Item 5.**Development Application: 1 Shakespeare Place, Sydney****File Number:** D/2024/868**Summary****Date of Submission:** 21 October 2024

Proposal Summary: Development consent is sought for the upgrade of the public domain surrounding the northern wing of the NSW

Figure 13: Indicative amendments shown in red to reintroduce additional turning lane to Shakespeare Place

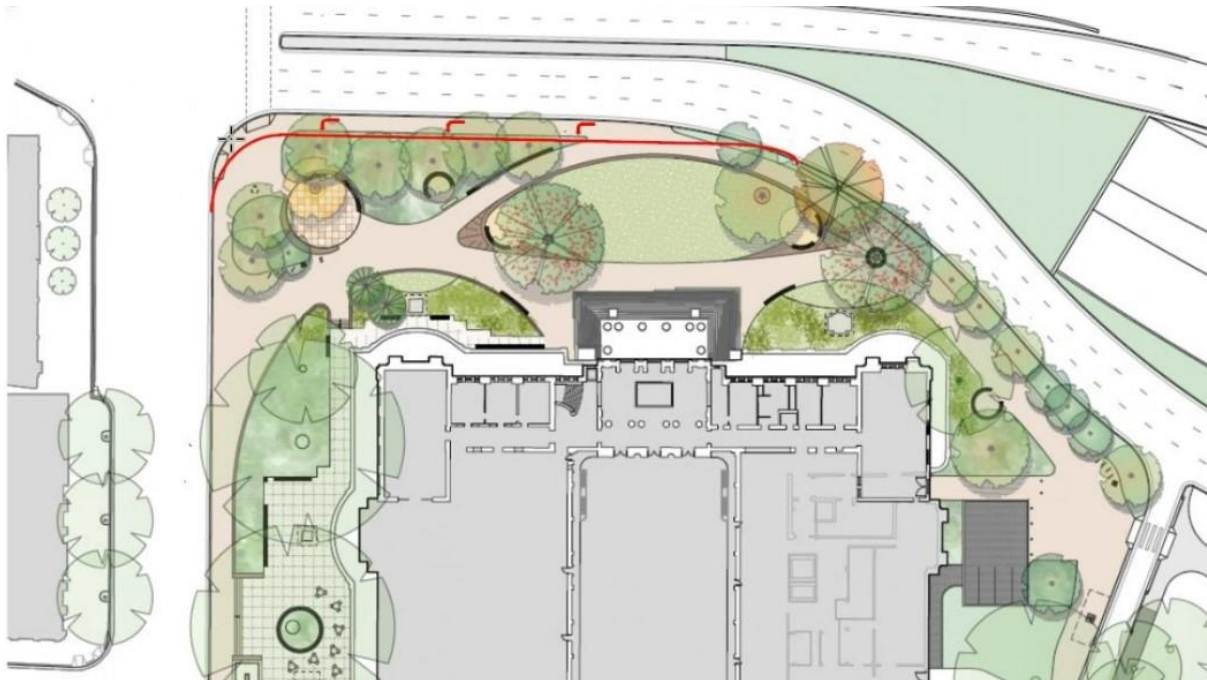
55. To ensure the development can deliver a roadway able to support existing and future roadways demands, advice issued by TfNSW requires design modifications including:

- (c) Introduction of a dedicated westbound left turn lane on Shakespeare Place into Macquarie Street to replace the removal of the left turn slip lane. The length of this dedicated left hand turn lane will be subject to detailed design assessment as part of the post consent Major Works Authorisation Deed (WAD) process.

56. Generally, this results in the reintroduction of a laneway on Shakespeare Place to allow a left turn onto Macquarie Street in place of the existing slip lane as shown in Figure 13 below.

57. As a result of this design change, other amendments are required to the road design including traffic flow changes to Bent Street and the increase in width of the footpath adjoining the road.
58. The above design changes were discussed with Council's Transport and Access Unit and Public Domain Unit who confirmed the traffic flow changes to Bent Street will not adversely impact the local road network and will generally improve pedestrian amenity by increasing footpath widths. Conditions of consent are recommended requiring updated drawings to be submitted prior to the commencement of Stage 2 to show

59. While the road design amendments are generally accepted, the reintroduction of an additional lane will result in a slightly reduced northern forecourt area and will require minor design amendments to respond to the modified space. It is unlikely that the design amendments to this forecourt area will significantly change the general layout or design intent, rather provide a forecourt area at a slightly reduced scale.
